## **E702 – Proposed District Centre Roundabout, Derby**

### **Stage 1 Road Safety Audit Response**

**Stage 1 Road Safety Audit**

**Chellaston Lane Roundabout**

#### 4.1.1. Problem

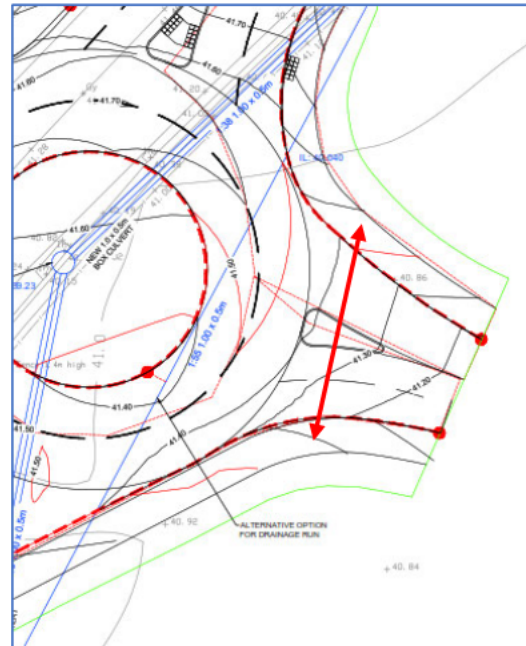
The development is likely to attract diverse pedestrian movements and desire routes. At present, there is evidence of pedestrian movements along verge areas and the development is likely to increase such use, to and from other facilities such as adjacent bus stops. Unmet pedestrian desire routes may lead to unexpected pedestrian crossing on the highway network. Mobility impaired users, such as those using wheelchairs may experience difficulty negotiating routes where upstand kerbs are provided, or where there is a lack of footway provision and this may result in vulnerable user falls and injury.

At the roundabout, the lack of crossing facilities across the development arm and southern Chellaston Lane arm of the junction may lead to unexpected crossing movements and the splitter islands may be used by pedestrians as crossing points which appear to be narrow and may not safely accommodate users.

It is recommended that likely pedestrian desire routes are assessed and appropriate provision made; at the roundabout, splitter islands may be locations for crossing opportunities and dropped kerb facilities may be appropriate; splitter islands may require to be widened to safely accommodate likely users. Any footway provision should link with existing facilities.

| Items Raised by Stage 1 Road Safety Audit        |                                                                                                                                                                                                                                                                                                                                                                                                                                                                                                                                                                                                                                                                                                                                                                                                                                                                                                                                                                                                                                                                                                                               |                                                                                                                                                                                                                                                                                                                                                                                        |                                                                                                                                                                                                                                                                                                                                                                                                                                                                                                                                                                                                                                                                                                                                                                                                                                                                                                                                                                                                                                                                                                                                                                                                                                                                                                                                                                                                |                            |
|--------------------------------------------------|-------------------------------------------------------------------------------------------------------------------------------------------------------------------------------------------------------------------------------------------------------------------------------------------------------------------------------------------------------------------------------------------------------------------------------------------------------------------------------------------------------------------------------------------------------------------------------------------------------------------------------------------------------------------------------------------------------------------------------------------------------------------------------------------------------------------------------------------------------------------------------------------------------------------------------------------------------------------------------------------------------------------------------------------------------------------------------------------------------------------------------|----------------------------------------------------------------------------------------------------------------------------------------------------------------------------------------------------------------------------------------------------------------------------------------------------------------------------------------------------------------------------------------|------------------------------------------------------------------------------------------------------------------------------------------------------------------------------------------------------------------------------------------------------------------------------------------------------------------------------------------------------------------------------------------------------------------------------------------------------------------------------------------------------------------------------------------------------------------------------------------------------------------------------------------------------------------------------------------------------------------------------------------------------------------------------------------------------------------------------------------------------------------------------------------------------------------------------------------------------------------------------------------------------------------------------------------------------------------------------------------------------------------------------------------------------------------------------------------------------------------------------------------------------------------------------------------------------------------------------------------------------------------------------------------------|----------------------------|
| 4.1.1                                            | <p><b>Location</b> – General to the Development</p> <p><b>Summary</b> – Unmet pedestrian desire routes may lead to pedestrian to vehicle collisions, or hazards for vulnerable users</p> <p>The development is likely to attract diverse pedestrian movements and desire routes. At present there is evidence of pedestrian movements along verge areas and the development is likely to increase such use, to and from other facilities such as the adjacent bus stops. Unmet pedestrian routes may lead to unexpected pedestrian crossing on the highway network. Mobility impaired users, such as those using wheelchairs may experience difficulty negotiating routes where upstand kerbs are provided, or where there is a lack of footway provision and this may result in vulnerable user falls and injury.</p> <p>At the roundabout, the lack of crossing facilities across the development arm and southern arm of the junction may lead to unexpected crossing movements and the splitter islands may be used by pedestrians as crossing points which appear to be narrow and may not safely accommodate users.</p> | It is recommended that likely pedestrian desire routes are assessed and appropriate provision is made, at the roundabout, splitter islands may be located for crossing opportunities and dropped kerb facilities may be appropriate, splitter islands may be require to be widened to safely accommodate likely users. Any footway provision should link with the existing facilities. | <p>The proposed roundabout will ultimately serve a district centre, however a separate infrastructure application has been submitted to secure access to the site. This application makes provision for uncontrolled crossings to be provided on the western and northern arms, which will link to the existing Woods Meadow development. However no onward footway / cycleway connections have been provided at this stage. These are addressed as part of the District Centre planning application</p> <p>There is no current or future footway link on the western side of Chellaston Lane and therefore an uncontrolled crossing on the southern arm is not proposed. Notwithstanding the above the splitter island could accommodate a 2.4m wide uncontrolled crossing with a minimum 2.3m crossing depth.</p> <p>The proposed district centre application identifies internal crossing locations of the spine road at key desire lines and a potential crossing of the eastern arm.. The splitter island has been designed to be able to accommodate a 2.4m wide uncontrolled crossing with a minimum 2.3m crossing depth.</p> <p>The proposed district centre planning application provided a review the proposed desire lines and shared footway / cycleway connections are proposed on these links. These are illustrated on the sustainable access plan contained at Appendix B.</p> |                            |

#### 4.1.2. Problem

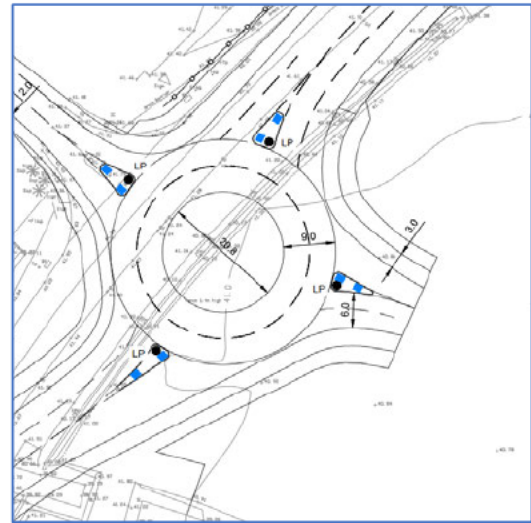
The development may attract diverse cycle movements and desire routes. There is an existing dual use footway / cycleway on the northern side of Shardlow Road and cyclists may be attracted to /from this facility. It is unclear whether there are connecting cycle facilities between the development and adjacent cycle facilities and a lack of facilities may lead to unexpected cycle crossing movements at the existing and proposed roundabouts, with consequent risk of cycle to vehicle collisions.

At the roundabout, the lack of crossing facilities for cyclists across the development arm of the junction (connecting two apparent 3m wide footway / cycleways) may lead to unexpected crossing movements and the splitter island may be used by cyclists as a crossing point which appears to be narrow and may not safely accommodate users.

It is recommended that likely cycle desire routes are assessed and appropriate provision made; at the roundabout, splitter islands may be locations for crossing opportunities and dropped kerb facilities may be appropriate; splitter islands may require to be widened to safely accommodate likely users. Any off-road cycle provision should link with existing facilities.

| Items Raised by Stage 1 Road Safety Audit        |                                                                                                                                                                                                                                                                                                                                                                                                                                                                                                                                                                                                                                                                                                                                                                                                                                                                                                                                                                                                                                                                                                                               |                                                                                                                                                                                                                                                                                                                                                                                        |                                                                                                                                                                                                                                                                                                                                                                                                                                                                                                                                                                                                                                                                                                                                                                                                                                                                                                                                                                                                                                                                                                                                                                                                                                                                                                                                                                                                |                            |
|--------------------------------------------------|-------------------------------------------------------------------------------------------------------------------------------------------------------------------------------------------------------------------------------------------------------------------------------------------------------------------------------------------------------------------------------------------------------------------------------------------------------------------------------------------------------------------------------------------------------------------------------------------------------------------------------------------------------------------------------------------------------------------------------------------------------------------------------------------------------------------------------------------------------------------------------------------------------------------------------------------------------------------------------------------------------------------------------------------------------------------------------------------------------------------------------|----------------------------------------------------------------------------------------------------------------------------------------------------------------------------------------------------------------------------------------------------------------------------------------------------------------------------------------------------------------------------------------|------------------------------------------------------------------------------------------------------------------------------------------------------------------------------------------------------------------------------------------------------------------------------------------------------------------------------------------------------------------------------------------------------------------------------------------------------------------------------------------------------------------------------------------------------------------------------------------------------------------------------------------------------------------------------------------------------------------------------------------------------------------------------------------------------------------------------------------------------------------------------------------------------------------------------------------------------------------------------------------------------------------------------------------------------------------------------------------------------------------------------------------------------------------------------------------------------------------------------------------------------------------------------------------------------------------------------------------------------------------------------------------------|----------------------------|
| 4.1.2                                            | <p><b>Location</b> – General to the Development</p> <p><b>Summary</b> – Unmet cycle desire routes may lead to pedestrian to vehicle collisions, or hazards for vulnerable users</p> <p>The development may attract diverse cycle movements and desire routes. There is an existing dual use footway / cycleway on the northern side of Shardlow Road and cyclists may be attracted to / from this facility. It is unclear whether there are connecting cycle facilities between the development and adjacent cycle facilities and a lack of facilities may lead to unexpected cycle crossing movements at the existing and proposed roundabouts, with consequent risk of cycle to vehicle collisions.</p> <p>At the roundabout the lack of crossing facilities for cyclists across the development arm of the junction (connecting two apparent 3m wide footway / cycleways) may lead to unexpected crossing movements and the splitter island may not safely accommodate users.</p>                                                                                                                                          | It is recommended that likely cycle desire routes are assessed and appropriate provision made; at the roundabout, splitter islands may be locations for crossing opportunities and dropped kerb facilities may be appropriate; splitter islands may require to be widened to safely accommodate users. Any off-road cycle provision should link with existing facilities.              | See, comment above.                                                                                                                                                                                                                                                                                                                                                                                                                                                                                                                                                                                                                                                                                                                                                                                                                                                                                                                                                                                                                                                                                                                                                                                                                                                                                                                                                                            |                            |

### 4.2.1. Problem

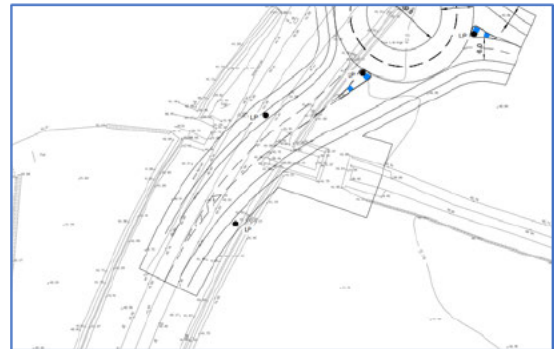
The traffic flow information indicates that approximately 1,000 vehicles per hour will be entering the roundabout from the northern arm and be proceeding southbound along Chellaston Lane during the AM peak hour. Unbalanced lane usage at the main road southbound entry may encourage drivers to use both lanes to proceed along Chellaston Lane. This may lead to late lane change or forced merge collisions on the circulatory carriageway or roundabout exit.

It is recommended that an assessment of the need for both entry lanes on the northern arm for the straight across movement should be carried out. If two lanes are required for capacity purposes then the exit should be widened to two lanes. The length of merge lane, if required, should be adequate to ensure safe merging at the exit. If a single lane is sufficient it may be appropriate to provide lane destination signing and markings to clarify lane usage.

| Items Raised by Stage 1 Road Safety Audit |                                                                                                                                                                                                                                                                                                                                                                                                                                                                                                                                                                                                                                                                                                    |                                                                                                                                                                                                                                                                                                                                                                                                                                                                  |                                                                                                                                                                                                                                                                                                                                                                                                                                                                                                                                                                                                                                                          |                            |
|-------------------------------------------|----------------------------------------------------------------------------------------------------------------------------------------------------------------------------------------------------------------------------------------------------------------------------------------------------------------------------------------------------------------------------------------------------------------------------------------------------------------------------------------------------------------------------------------------------------------------------------------------------------------------------------------------------------------------------------------------------|------------------------------------------------------------------------------------------------------------------------------------------------------------------------------------------------------------------------------------------------------------------------------------------------------------------------------------------------------------------------------------------------------------------------------------------------------------------|----------------------------------------------------------------------------------------------------------------------------------------------------------------------------------------------------------------------------------------------------------------------------------------------------------------------------------------------------------------------------------------------------------------------------------------------------------------------------------------------------------------------------------------------------------------------------------------------------------------------------------------------------------|----------------------------|
| 4.2.1                                     | <p><b>Location:</b> At the proposed roundabout</p> <p><b>Summary:</b> Unbalanced lane usage may lead to lane change side-swipe collisions</p> <p>The traffic flow information indicates that approximately 1,000 vehicles per hour will be entering the roundabout from the northern arm and be proceeding southbound along Chellaston Lane during the AM peak hour. Unbalanced lane usage at the main road southbound entry may encourage drivers to use both lanes to proceed along Chellaston Lane. This may lead to late lane change or forced merge collisions on the circulatory carriageway or roundabout exit.</p>                                                                         | <p>It is recommended that an assessment of the need for both entry lanes on the northern arm for the straight across movement should be carried out. If two lanes are required for capacity purposes then the exit should be widened to two lanes. The length of merge lane, if required, should be adequate to ensure safe merging at the exit. If a single lane is sufficient it may be appropriate to provide lane destination markings to clarify usage.</p> | <p>Lane destination markings will be reviewed and provided on the northbound and southbound approaches, which will be agreed during detailed design.</p> <p>In addition the exit taper will be reviewed at detailed design and agreed as part of the S.278 process.</p>                                                                                                                                                                                                                                                                                                                                                                                  |                            |

#### 4.2.2. Problem

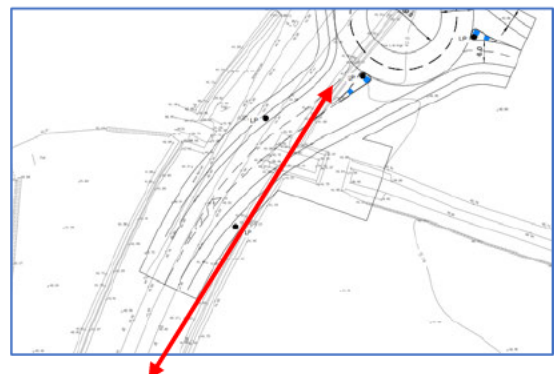
The right hand horizontal curve for northbound users 'tightens' on the approach to the proposed roundabout. The existing superelevation appears to be severe (and may have been introduced due to the previous design speed for the road). The change in horizontal alignment and application of superelevation may lead to an increased risk of loss of control type collisions. Motorcyclists may be particularly vulnerable to loss of control where the bend tightens.

It is recommended that the horizontal curve is made a constant radius and that any superelevation applied is consistent with the reduced design speed and limit.

| Items Raised by Stage 1 Road Safety Audit |                                                                                                                                                                                                                                                                                                                                                                                                                                                                                                                                                                                                                                                                                                    |                                                                                                                                                                                                                                                                                                                                                                                                                                                                  |                                                                                                                                                                                                                                                                                                                                                                                                                                                                                                                                                                                                                                                          |                            |
|-------------------------------------------|----------------------------------------------------------------------------------------------------------------------------------------------------------------------------------------------------------------------------------------------------------------------------------------------------------------------------------------------------------------------------------------------------------------------------------------------------------------------------------------------------------------------------------------------------------------------------------------------------------------------------------------------------------------------------------------------------|------------------------------------------------------------------------------------------------------------------------------------------------------------------------------------------------------------------------------------------------------------------------------------------------------------------------------------------------------------------------------------------------------------------------------------------------------------------|----------------------------------------------------------------------------------------------------------------------------------------------------------------------------------------------------------------------------------------------------------------------------------------------------------------------------------------------------------------------------------------------------------------------------------------------------------------------------------------------------------------------------------------------------------------------------------------------------------------------------------------------------------|----------------------------|
| 4.2.2                                     | <p><b>Location:</b> On Chellaston Lane</p> <p><b>Summary:</b> Change in horizontal alignment may lead to loss of control type collisions.</p> <p>The right hand horizontal curve for northbound users 'tightens' on the approach to the proposed roundabout. The existing superelevation appears to be severe (and may have been introduced due to the previous design speed for the road). The change in horizontal alignment and application of superelevation may lead to an increased risk of loss of control type collisions. Motorcyclists may be particularly vulnerable to loss of control where the bend tightens.</p>                                                                    | <p>It is recommended that the horizontal curve is made a constant radius and that any superelevation applied is consistent with the reduced design speed and limit.</p>                                                                                                                                                                                                                                                                                          | <p>The centre line has been designed with a constant radius, however the radius/alignment used will be reviewed and agreed at detailed design</p> <p>The proposed levels including superelevation will be reviewed and agreed as part of the detailed design process.</p>                                                                                                                                                                                                                                                                                                                                                                                |                            |
